Urgent Field Safety Notice (FSN)

Replacing the power supply unit
for care beds in the Ecofit range

13.05.2024

Plug-in power supply SMPS - PS1102

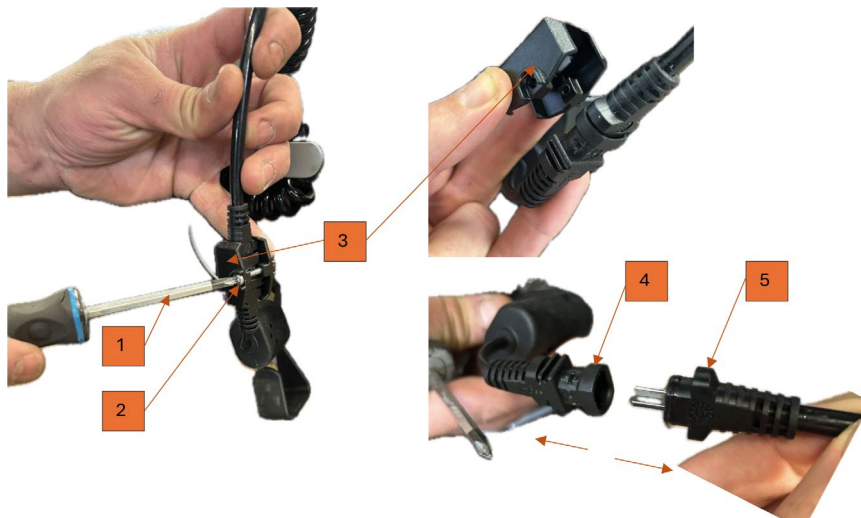
Please replace the MC115L-90-EU power supply unit with the PS1102 power supply unit provided free of charge by tecfor care for care beds from the Ecofit range in your inventory or during the next maintenance. Instructions for replacement can be found in the appendix to this letter.

1. To remove the previously installed power supply unit, use a screwdriver (1) to loosen the screw (2) on the safety cap of the plug connection.
2. You can then remove the protective cap (3) with little effort.
3. Now release the plug connection (4+5) by pulling in the opposite direction.

1. Take the new plug from the scope of delivery and fit it in the opposite direction as described in the "Disassembly" section.
2. Once steps 3-1 have been carried out, the power supply unit is ready for use and can be reconnected to the mains supply.
